TRI-STATE GENERATION & TRANSMISSION, INC.

FOX RUN SUBSTATION FINAL DRAINAGE REPORT

PCD FILE # PPR-22-044

October 11, 2022

SHEET NO. A-1

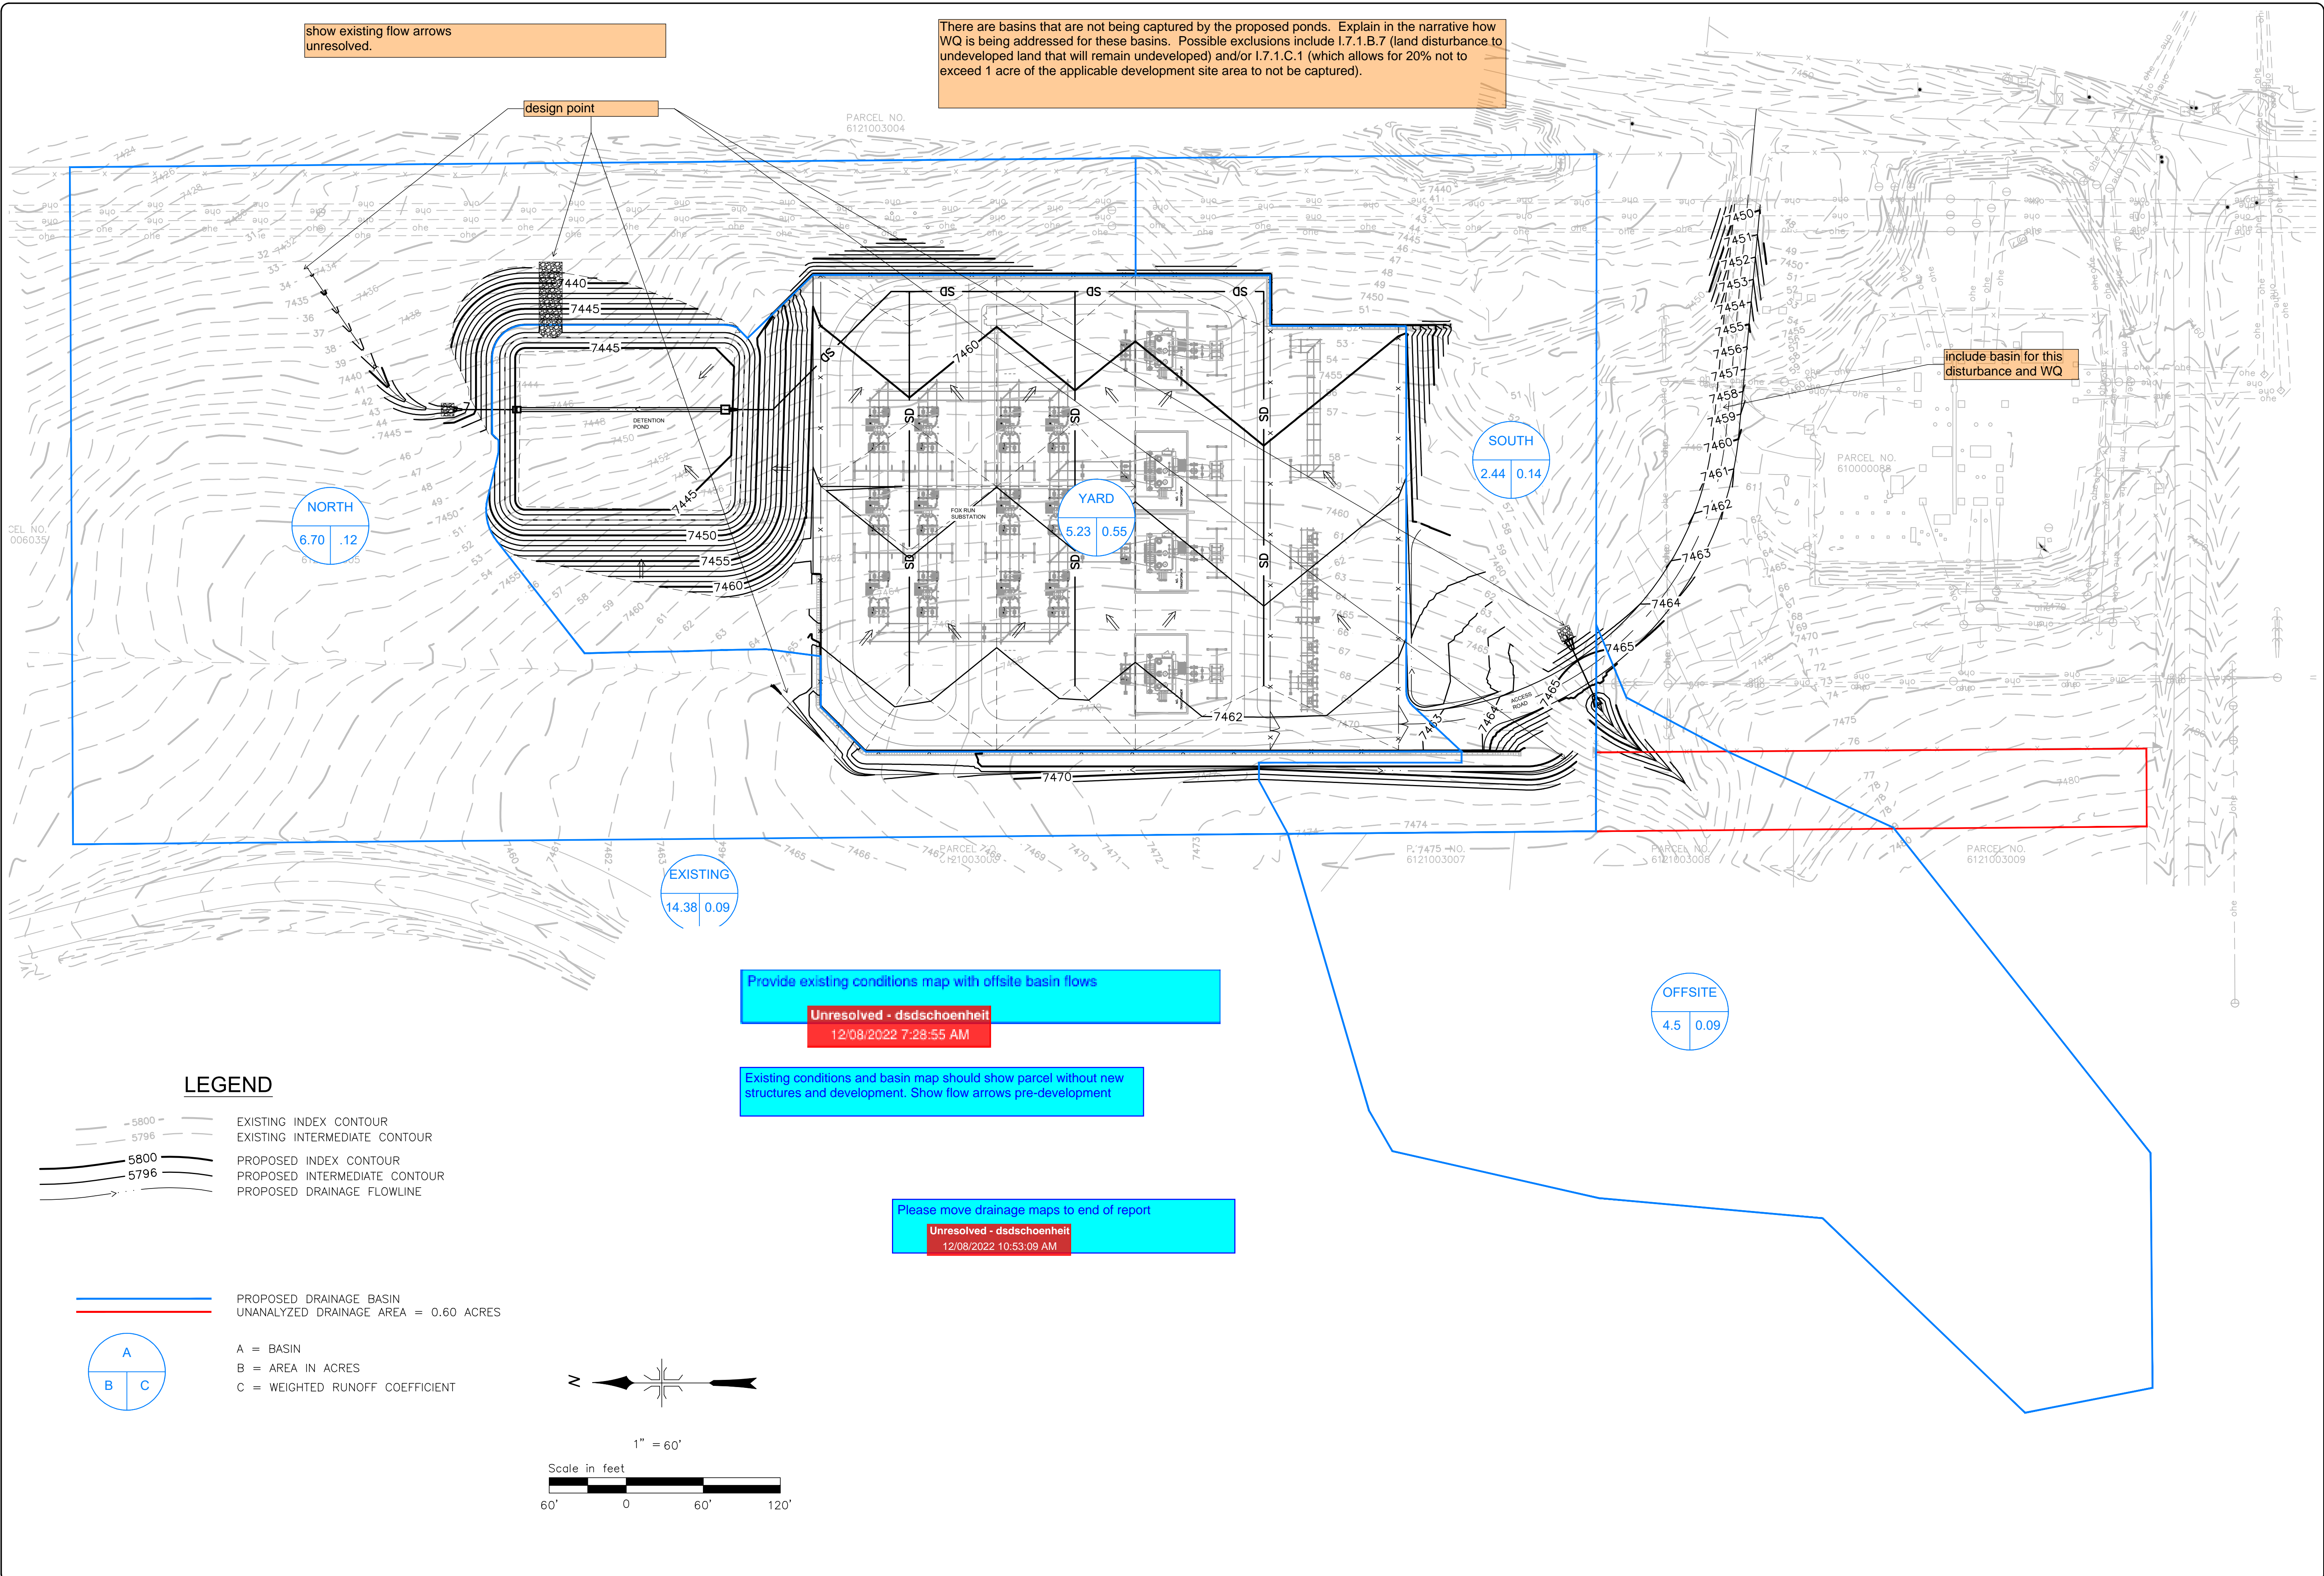
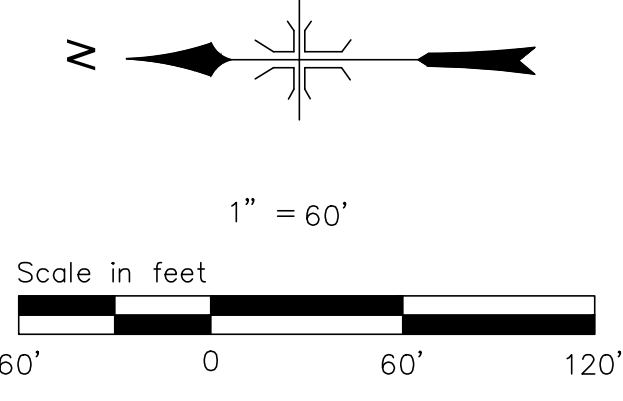
move to end of report

show existing flow arrows unresolved.

There are basins that are not being captured by the proposed ponds. Explain in the narrative how WQ is being addressed for these basins. Possible exclusions include I.7.1.B.7 (land disturbance to undeveloped land that will remain undeveloped) and/or I.7.1.C.1 (which allows for 20% not to exceed 1 acre of the applicable development site area to not be captured).

include basin for this disturbance and WQ

Provide existing conditions map with offsite basin flows
Unresolved - ddschoenheit
12/08/2022 7:28:55 AM

Existing conditions and basin map should show parcel without new structures and development. Show flow arrows pre-development

Please move drainage maps to end of report
Unresolved - ddschoenheit
12/08/2022 10:53:09 AM

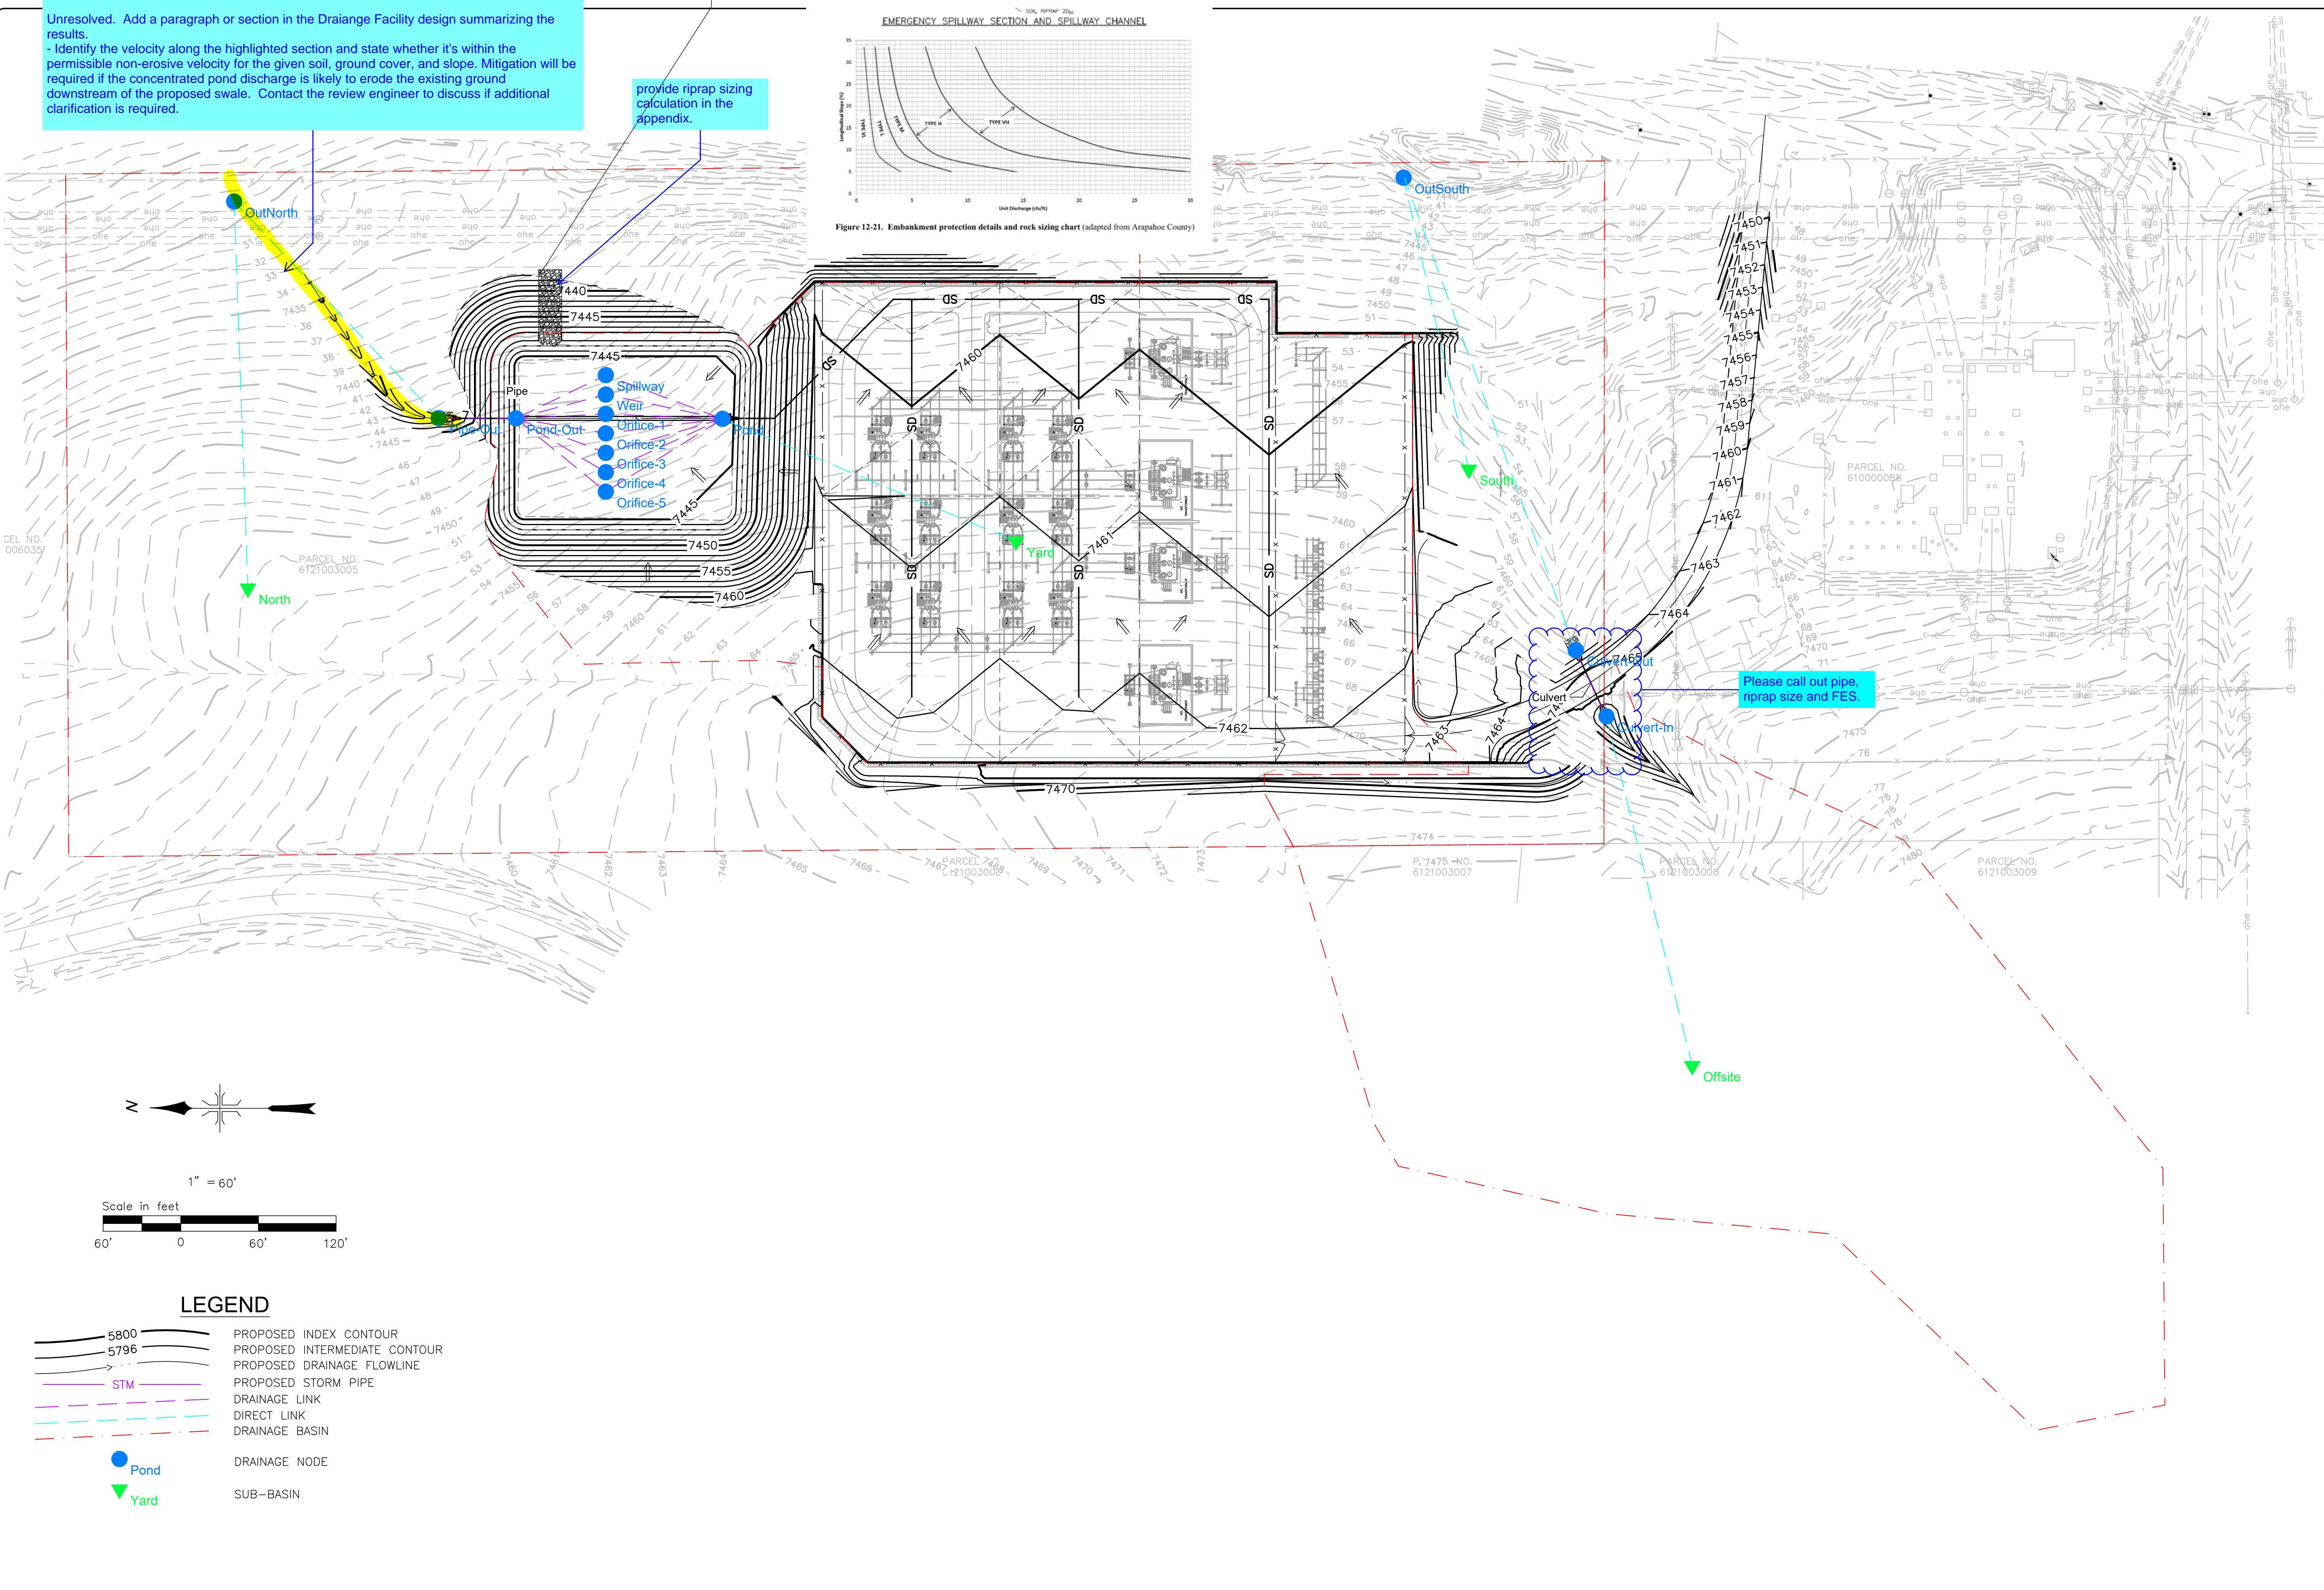
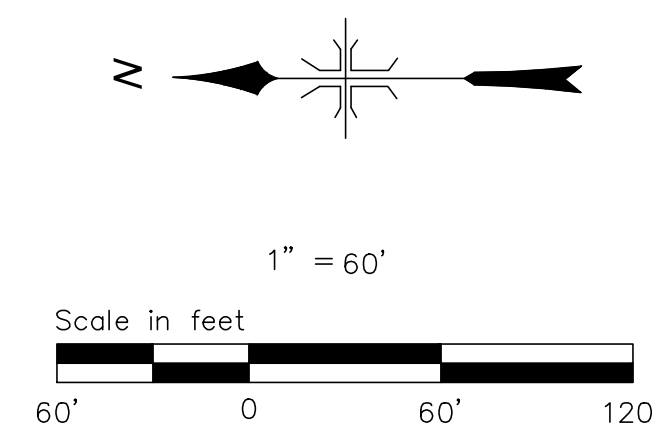
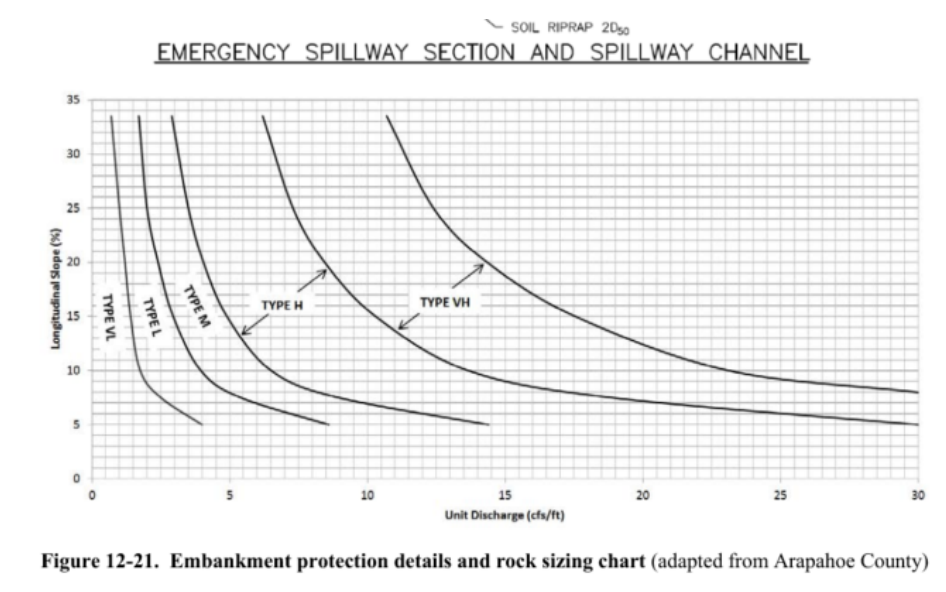
The manner of flow from sheet flow to concentrated flow. Analyze the conveyance path up to the suitable outfall as defined in ECM 3.2.4. The conveyance path must be hydraulically adequate/stable.

Unresolved. Add a paragraph or section in the Drainage Facility design summarizing the results.

- Identify the velocity along the highlighted section and state whether it's within the permissible non-erosive velocity for the given soil, ground cover, and slope. Mitigation will be required if the concentrated pond discharge is likely to erode the existing ground downstream of the proposed swale. Contact the review engineer to discuss if additional clarification is required.

Determine if this a suitable outfall. Where will the overflow be directed?

provide riprap sizing calculation in the appendix.

DETENTION BASIN OUTLET STRUCTURE DESIGN

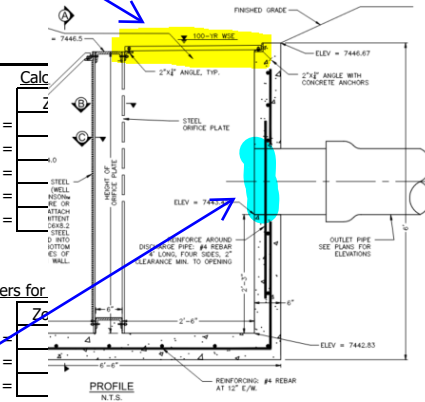
Change Zone 2 to Orifice Plate

Update Zone 3 to Weir & pipe (w/ Restrictor Plate)

Height needs to match the outlet height from the micropool to the top of grate.

Provide input to model the top of the outlet structure.

provide input to model the outlet pipe

change side slopes to "4" per plans
